Economic Commission for Europe
Inland Transport Committee
World Forum for Harmonization of Vehicle Regulations
Working Party on Passive Safety
Sixty-second session

Geneva, 12-15 December 2017

**Report of the Working Party on Passive Safety on its
sixty-second session**
Contents

Appendix 5, paragraph 4, correct to read:

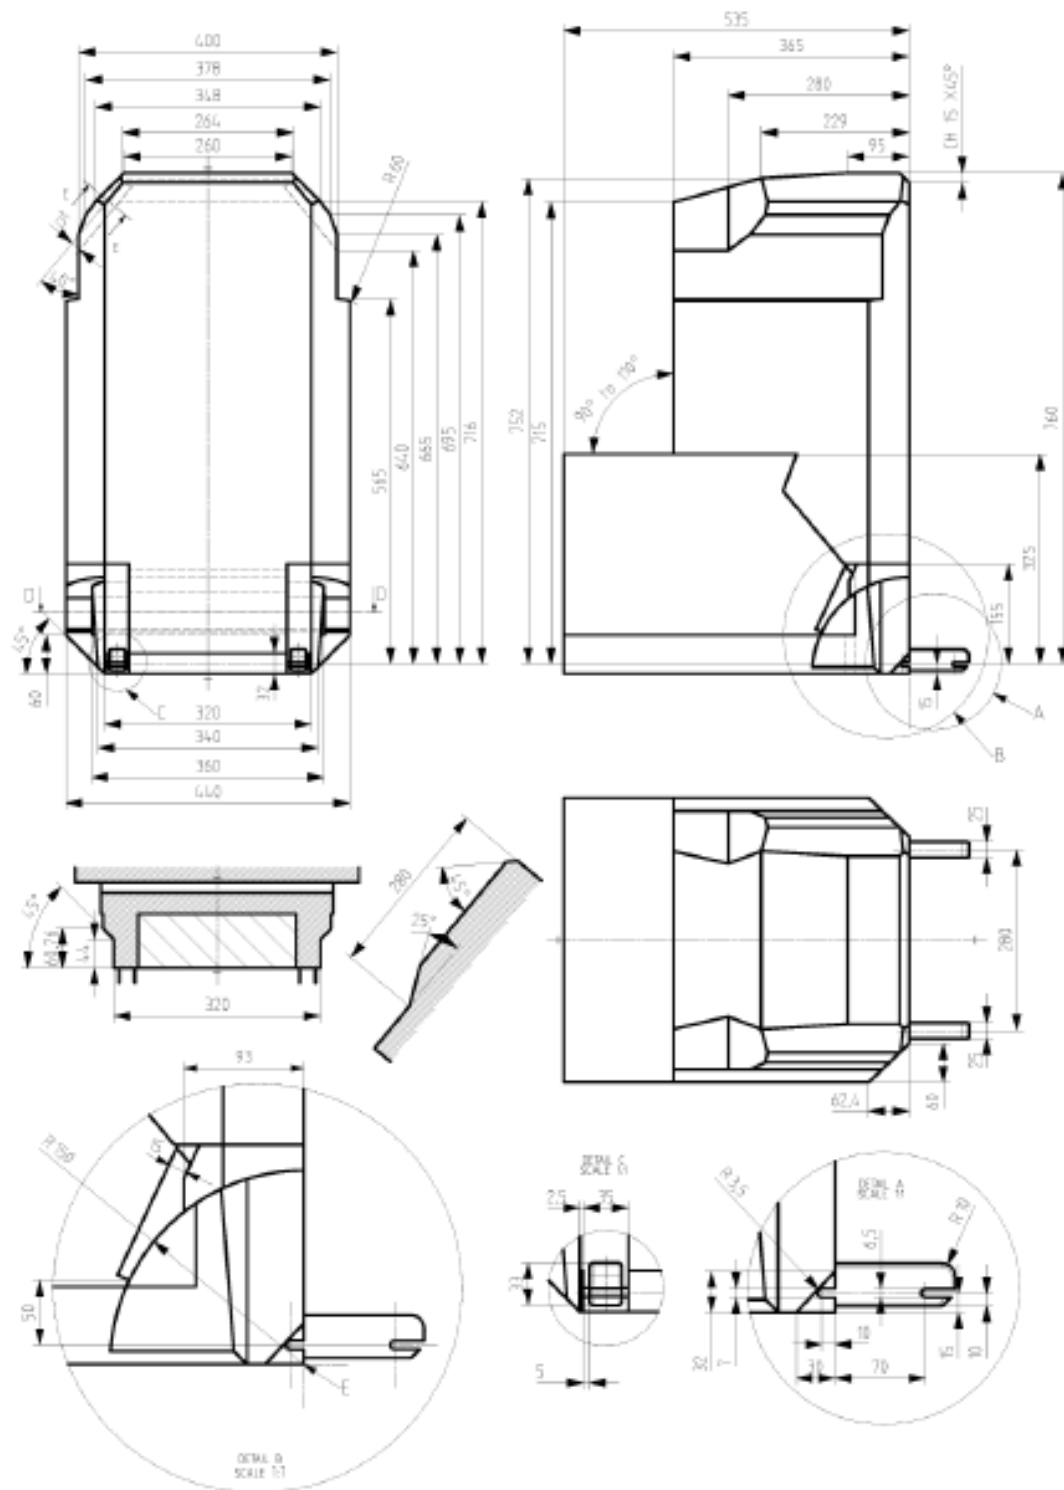
"4. Booster seat child restraint system fixtures:

The fixtures above shall be constructed with a mass of 7 kg +/- 1 kg and shall be of suitable durability and stiffness to satisfy the functional requirements."

Annex 12, amend to read:

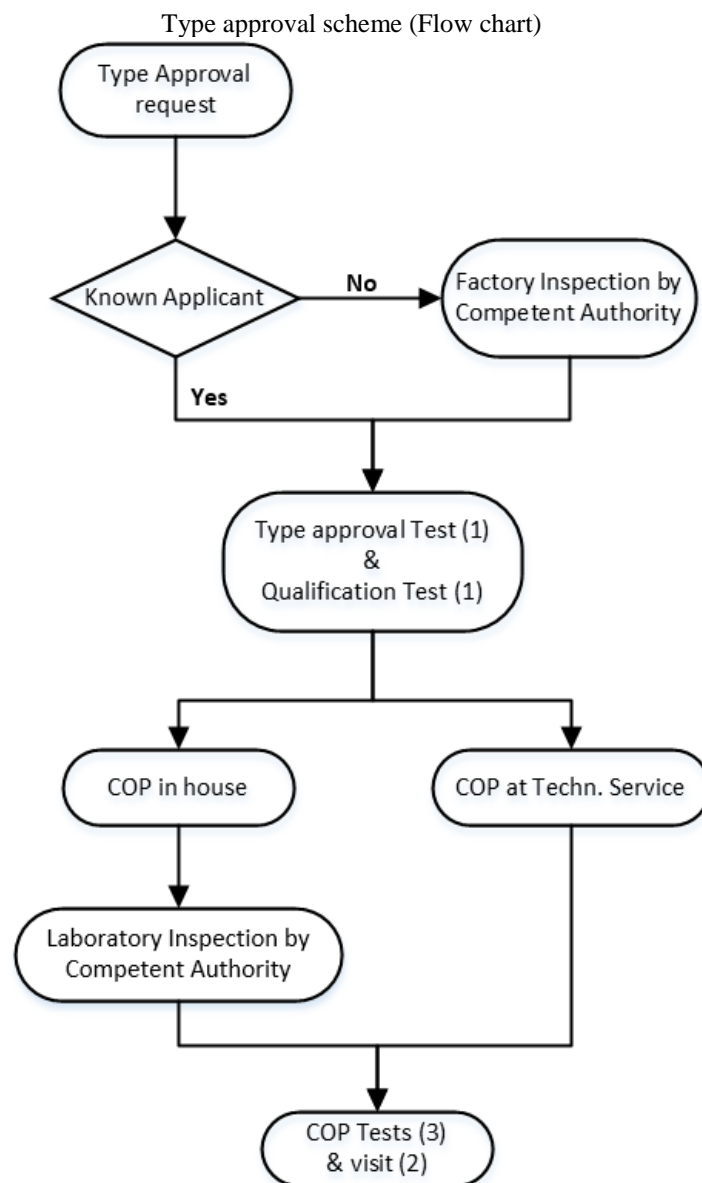
Amendments adopted on the basis of GRSP-62-04 (see para. 18 of this report)

- (1) To be carried out at the same technical service or the same accredited independent laboratory.
 - (2) Visit of the manufacturer for inspection and random sampling by the authority or technical service:
 - (a) if there is no ISO 9002* or an equivalent standard : **1** times a year
 - (b) if there is an ISO 9002* or an equivalent standard : 1 time **every 1 to 2 years, depending on the results of the inspection.**
 - (3) Tests in accordance to paragraph 10.5 and/or 10.6 on samples taken out of the production:
 - (a) if there is no ISO 9002* : of the authority or technical service during the visit of footnote 2 a) of the manufacturer between the visits of footnote 2 a)
 - (b) if there is an ISO 9002* : taken by the manufacturer, procedure checked during visit of footnote 2 b)
- * **or an equivalent standard, i.e. one that delivers the same or better levels of quality."**

Figures for the explanation of the measurement procedure

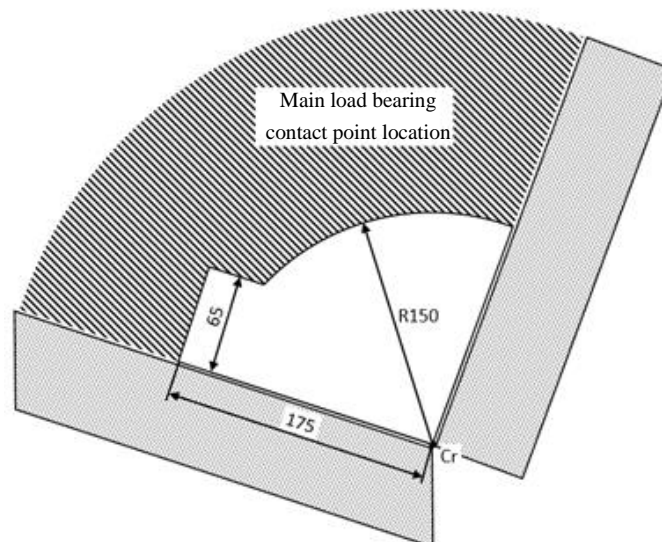
Paragraph 6.1.8., amend to read:

- "6.1.8. Integral child restraint ... without a dummy.

Figures of Strapped child

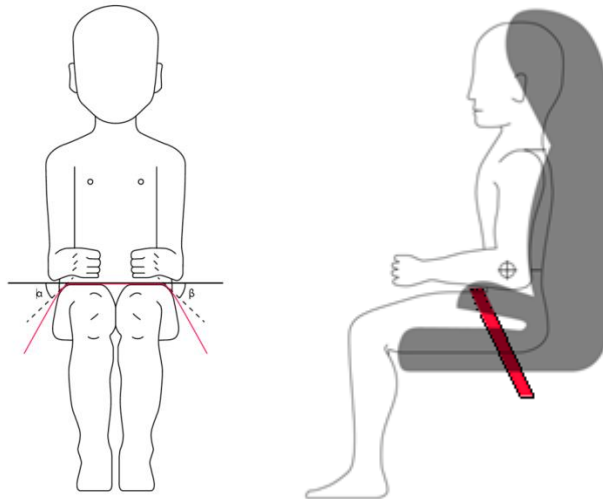
"6.2.1.5. All restraint ... excessive stresses.

In the case of booster seats, the lap portion of the adult safety-belt shall be positively guided on both sides to ensure that the loads transmitted by the adult lap belt are transmitted through the pelvis. The positive guidance of loads over the pelvis shall be realised from the moment that the child is installed; the lap belt shall pass over the top of the thigh, just touching the fold with the pelvis. The angles α and β between the tangent line in which the belt touches the thighs and the horizontal shall be greater than 10° .

The shoulder portion of the adult safety belt shall be positively guided to ensure that the child torso and neck do not escape."
